COTTAGE OAKS SUBDIVISION

Revised for the May 17, 2007 meeting:

DETAIL SITE PLAN

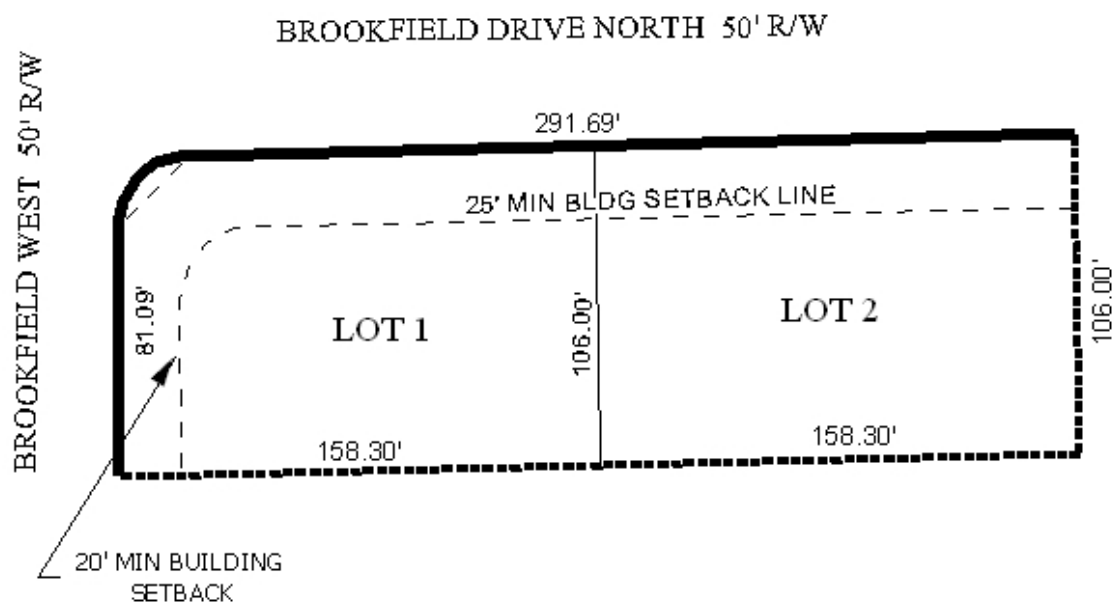
The lots meet the minimum size requirements of the Subdivision Regulations and are labeled with their size in square feet. The size of Lot 1, however, is incorrect and should be corrected for the final plat, if approved.

The plat depicts a 25-foot minimum building setback line from Brookfield Drive North, but only a 20-foot setback line from Brookfield Drive West. The Subdivision Regulations require that the setback from all streets be 25-feet: a 20-foot sideyard setback is allowed on corner lots by the Zoning Ordinance in Single-Family Residential districts. If the applicant wishes to request a 20-foot setback, an application for Planned Unit Development should be provided and the Subdivision application should be heldover to coincide with the PUD application.

The revised plat depicts a two lot subdivision with a 25-foot minimum building setback line along Brookfield Drive North, and a 20-foot minimum building setback line along Brookfield Drive West.

Proposed Lot 1 should be limited to one curb-cut either onto Brookfield Drive North or Brookfield Drive West, but not both, while Lot 2 should be limited to one curb-cut, with the size, design and location of all curb-cuts to be approved by Traffic Engineering and comply with AASHTO standards.

The Subdivision Regulations require that the setback from all streets be 25-feet: a 20-foot side yard setback is allowed on corner lots by the Zoning Ordinance in Single-Family Residential districts. The Planning Commission may waive the 25-foot setback, required by Section V.D.9. of the Subdivision Regulations, however, any residence built on Lot 1 would be required to face Brookfield Drive North.

Based upon the revised plat, the application is recommended for Tentative Approval, subject to the following conditions:

- 1) placement of a note on the final plat stating that Lot 1 is limited to one curb-cut either onto Brookfield Drive North and Brookfield Drive West, and that Lot 2 is limited to one-curb cut, with the size, design and location of all curb-cuts to be approved by Traffic Engineering and conform to AASHTO standards;*
- 2) revision of the plat to show a 25-foot minimum building setback from all street frontages; and*
- 3) full compliance with all municipal codes and ordinances.*
